SUBDIVISION REVIEW SHEET

CASE NO.: C8-2010-0070.0A

SUBDIVISION NAME: Era McClish Subdivision, Resubdivision of Lot C

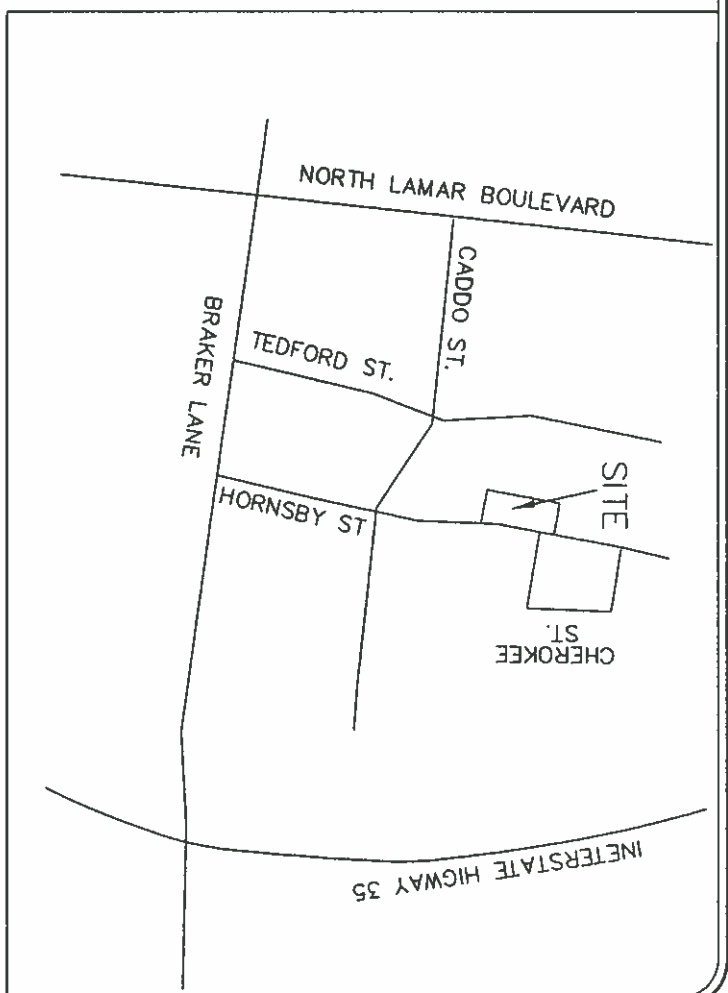
DEPARTMENT COMMENTS: The request is for approval of the Era McClish Subdivision, Resubdivision of Lot C. The proposed plat is composed of 2 lots on .5 acres.

STAFF RECOMMENDATION: The staff recommends disapproval of the plat. This plat does not meet all applicable State and City of Austin LDC requirements.
